**EAST GOSHEN TOWNSHIP
PLANNING COMMISSION
Meeting Agenda
Wednesday, July 1, 2020
VIA Telephone / Video Conference
7:00 PM**

Date: 6/25/2020
To: Planning Commission
From: Mark Gordon, Township Zoning Officer *mlg*
Re: Synthes USA / JABIL / Land Development Application

**RE: Jabil Finishing Plant Expansion, 1303 Goshen Parkway
Preliminary/Final Land Development Plan – 2nd Submission**

RE: 1303 Goshen Parkway – Preliminary / Final Land Development
Jabil Finishing Plant Expansion
1303 Goshen Parkway, West Chester, PA 19380
Mainstay Project Number: 19360
Pennoni / EGT Reference: EGOST00131

Drawing No. C1.11

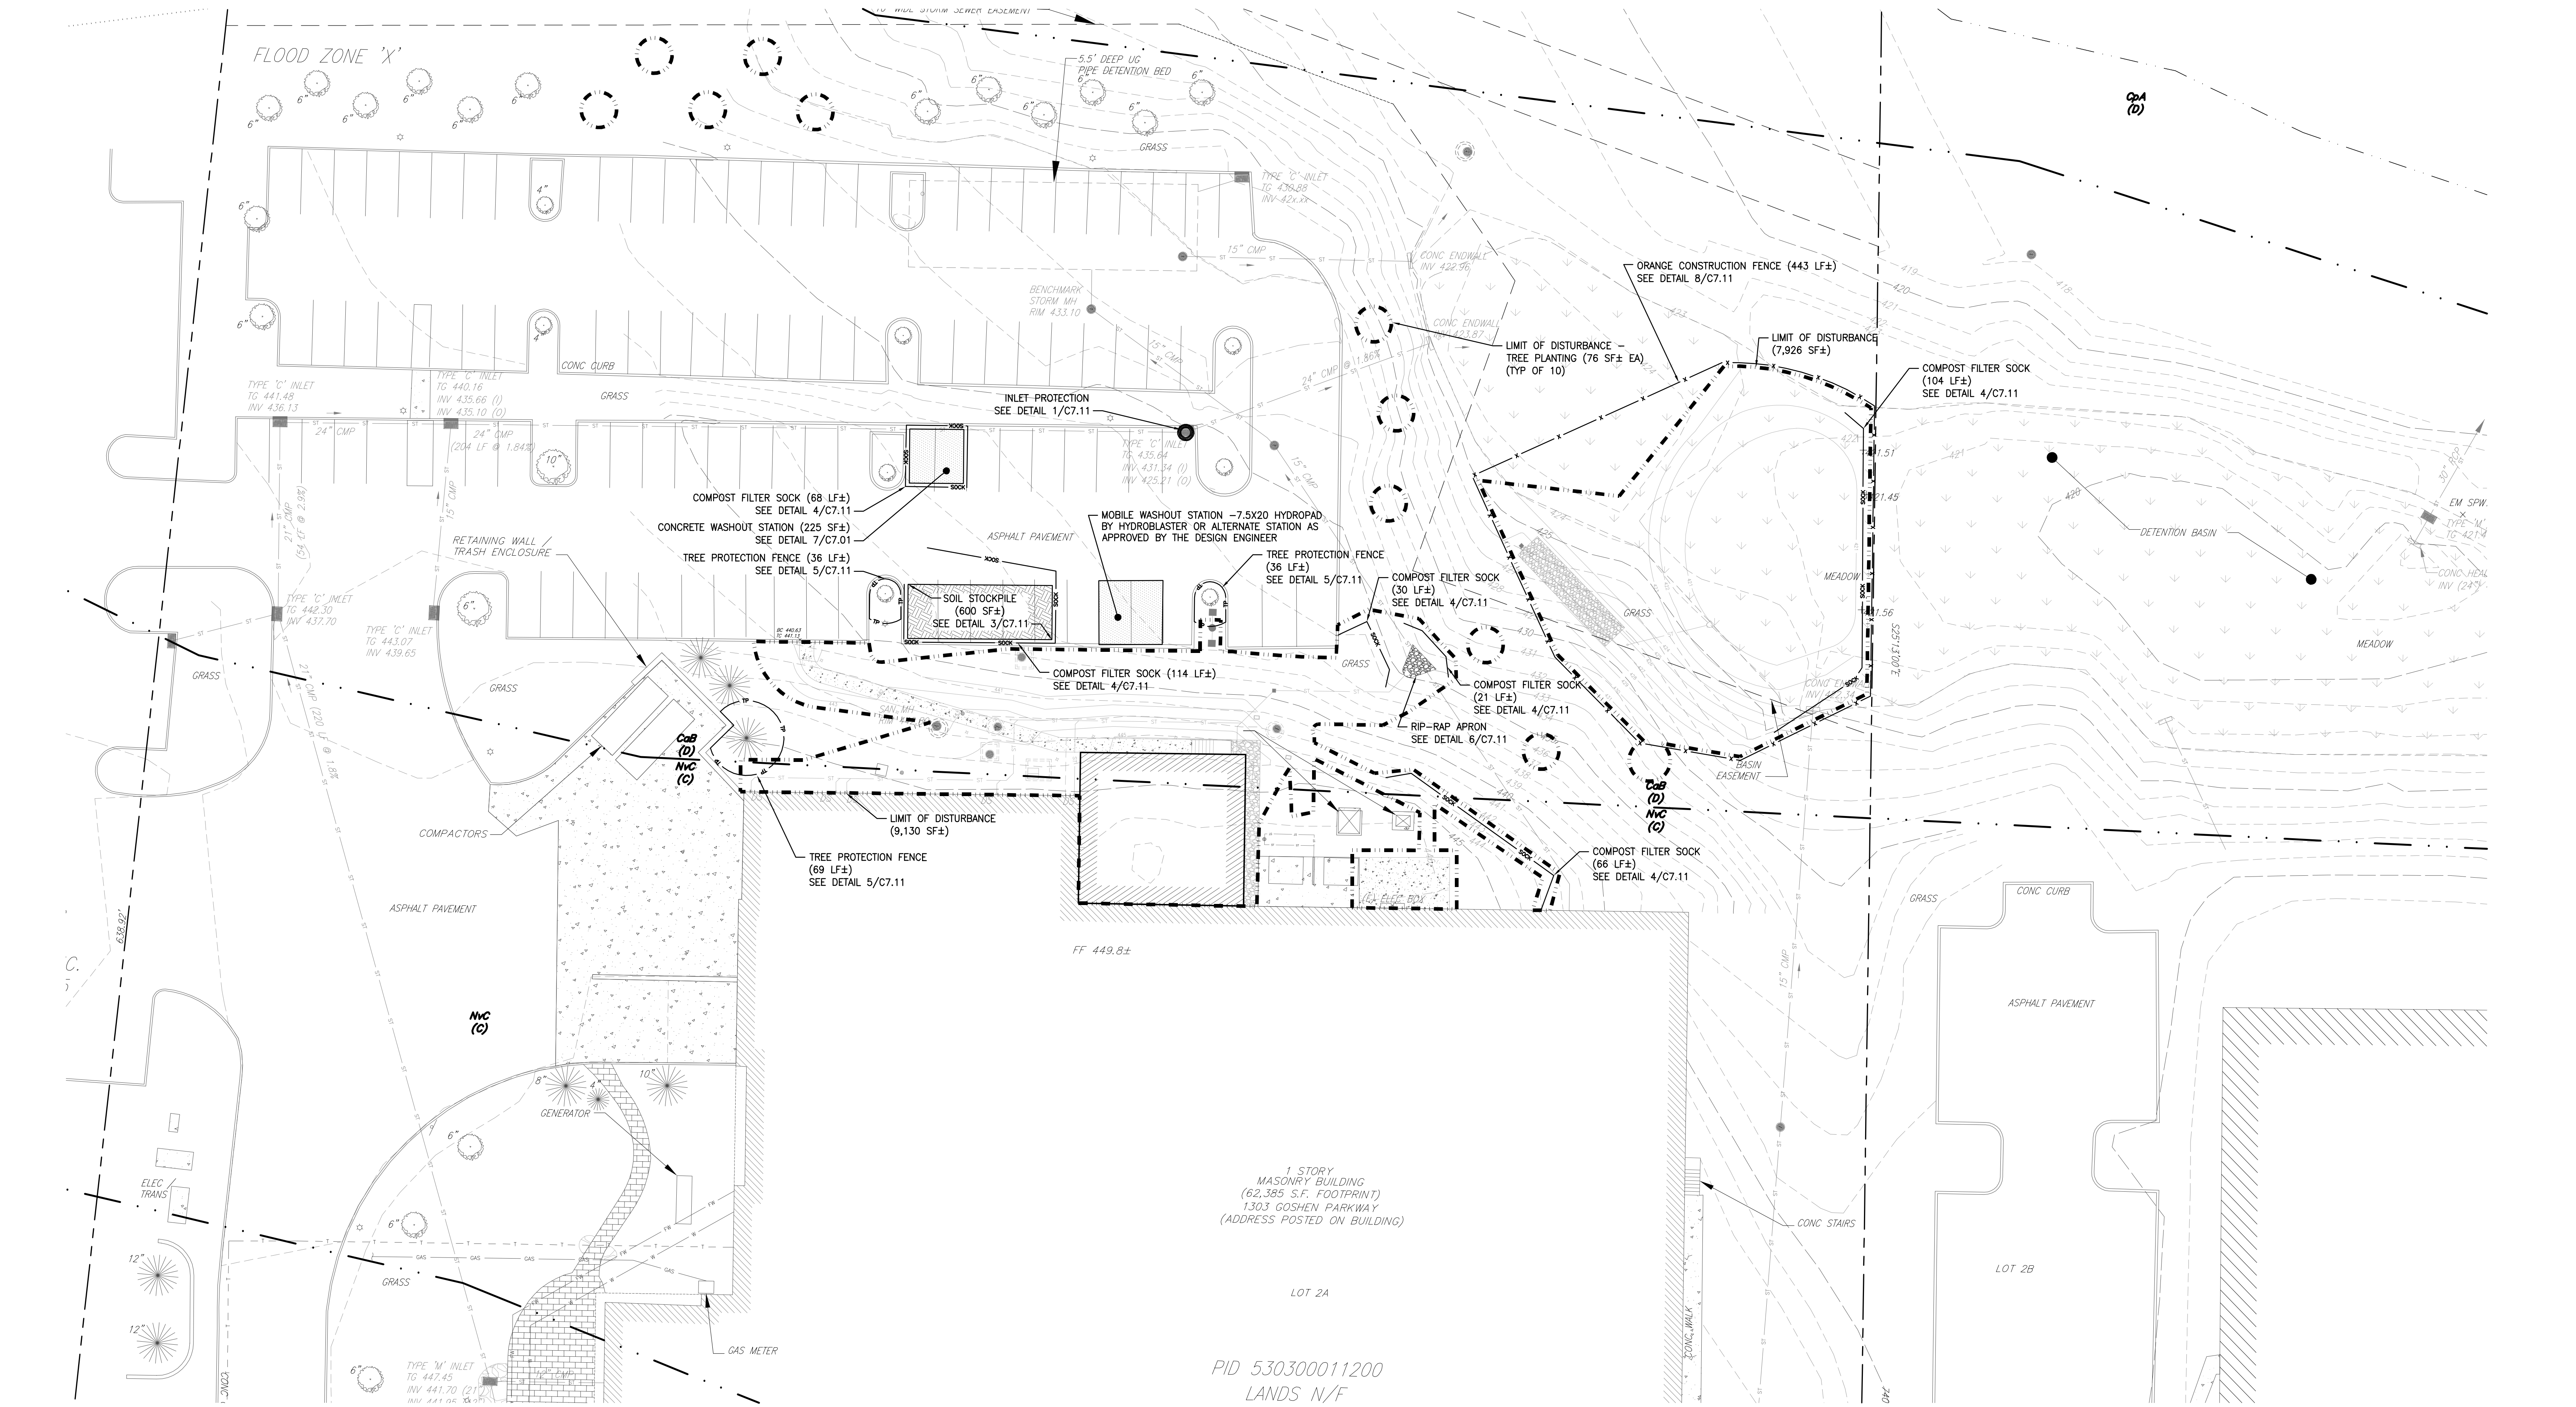
- b. Provide a means to prevent sediment from being deposited on public roads, such as a rock construction entrance and/or wash station.

Construction fencing has been added around the infiltration basin area on the Conservation Plan (Sheet C1.11) and a detail has been added on the Conservation Details (Sheet C7.11).

A mobile wash station has been added to the Conservation Plan (Sheet C1.11).

A concrete washout has been added on the Conservation Plan (Sheet C1.11) and a detail has been added on the Conservation Details (Sheet C7.11).

A soil stockpile has been added on the Conservation Plan (Sheet C1.11) referring to the detail located on the Conservation Details (Sheet C7.11).

1
C3.21
SCALE: NTS

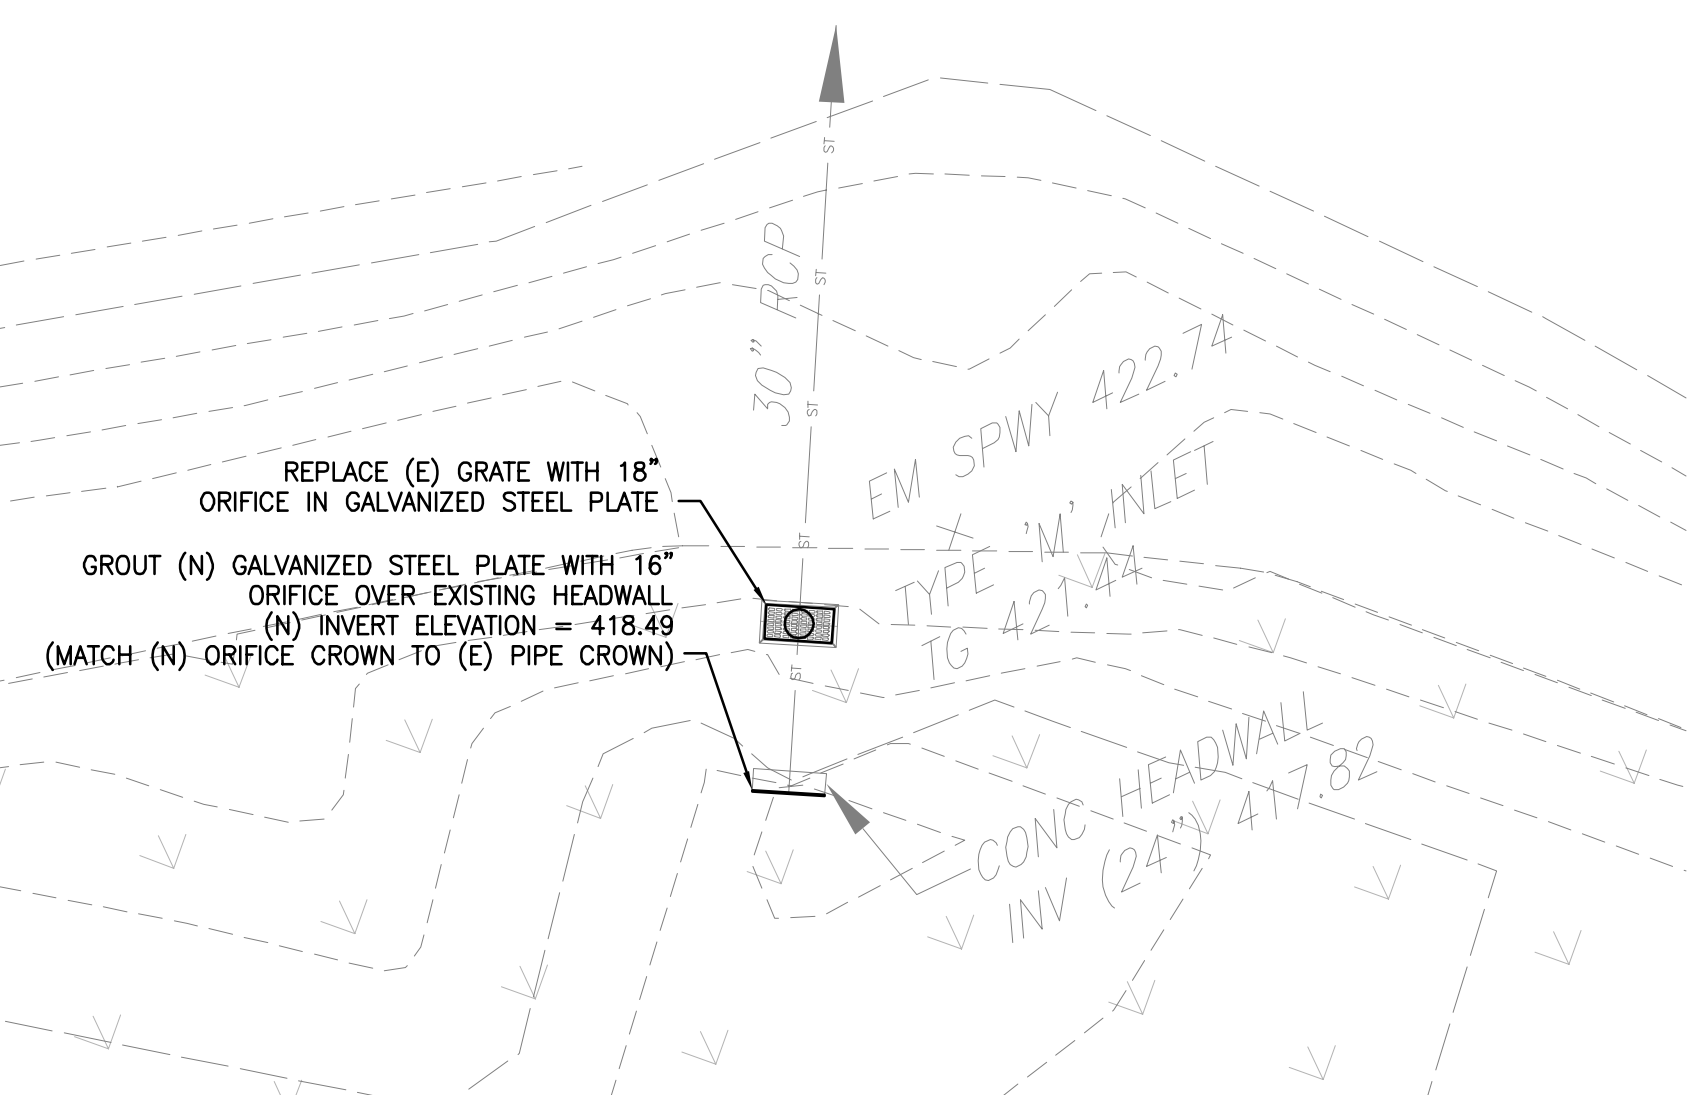
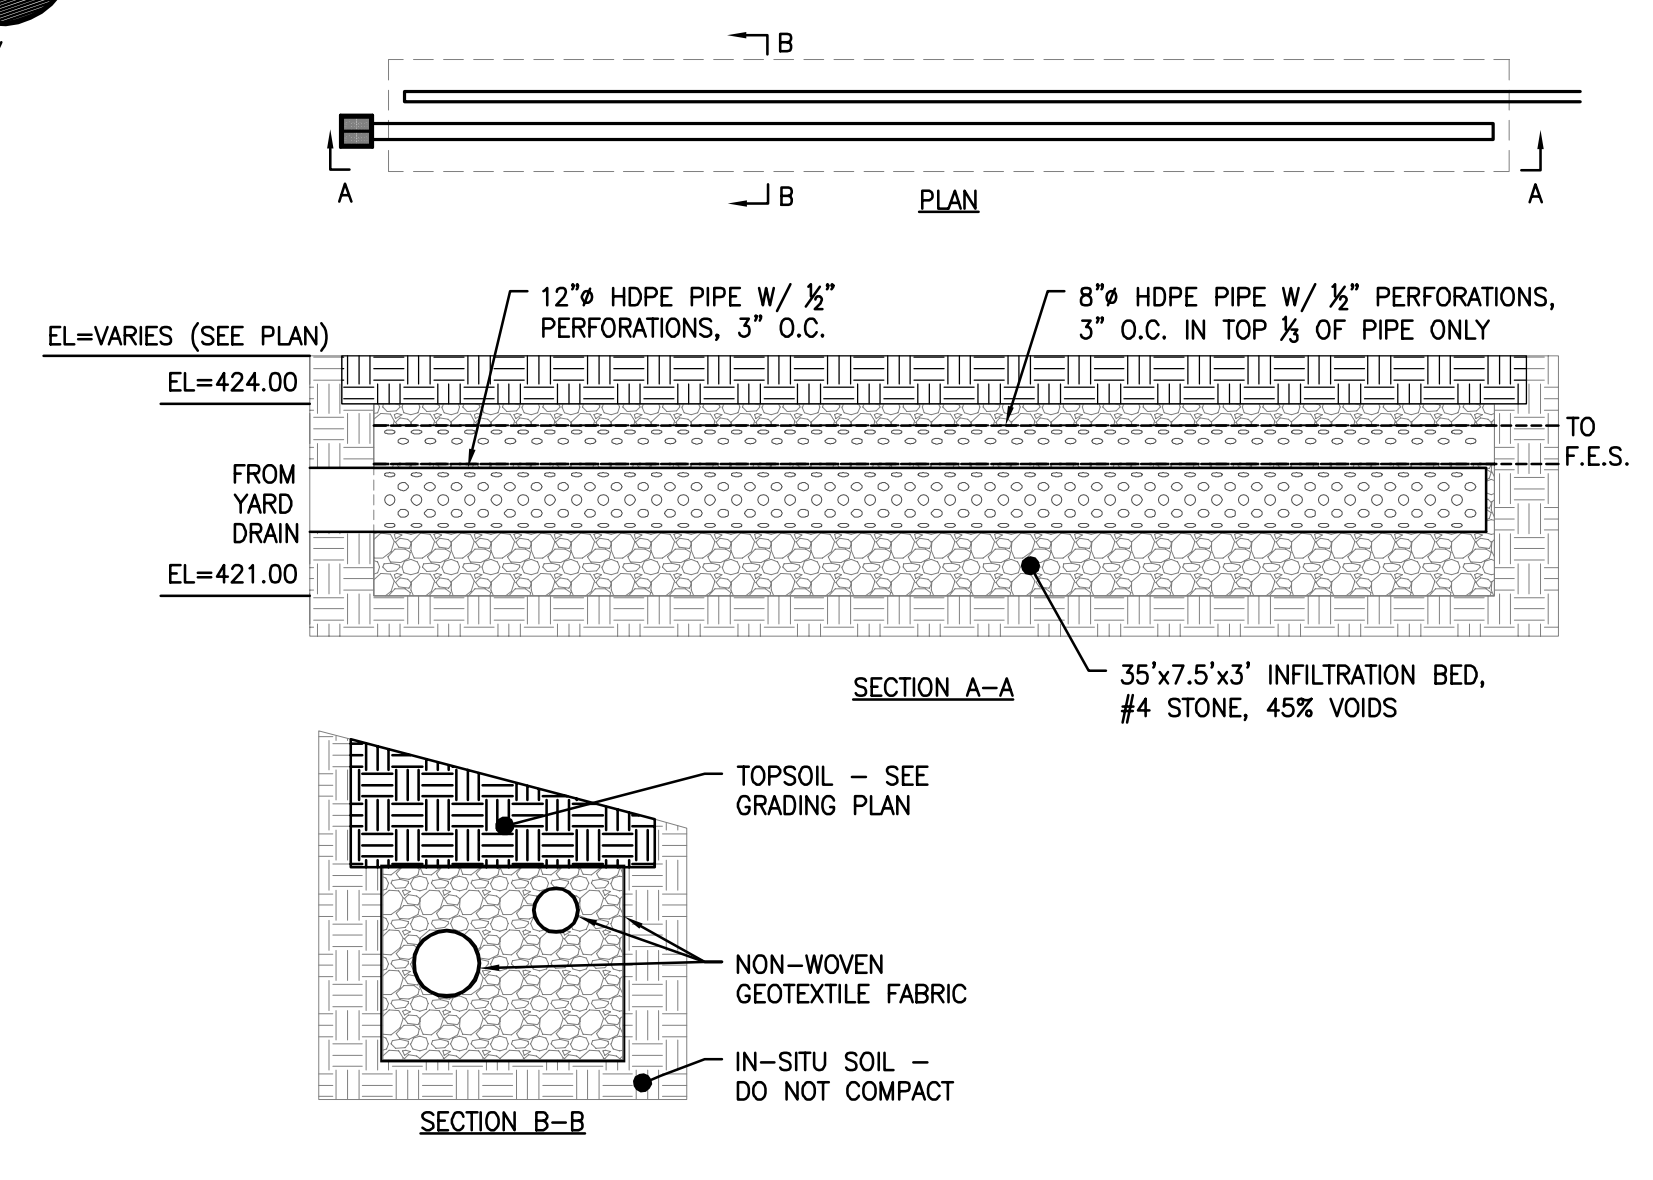
17. All infiltration practices shall have appropriate positive overflow controls. Please provide a detail and routing calculations for the proposed BMP.

21. A detail for the proposed infiltration BMP shall be provided. (§195-27.B(13))

Resolved. The applicant has provided a detail on Sheet C3.21.

A detail of the infiltration facility is provided on C3.21. An overflow pipe with top-third perforations is located near the top of the infiltration facility. Any overflow from the infiltration basin will enter the detention basin.

A detail has been added to C3.21.
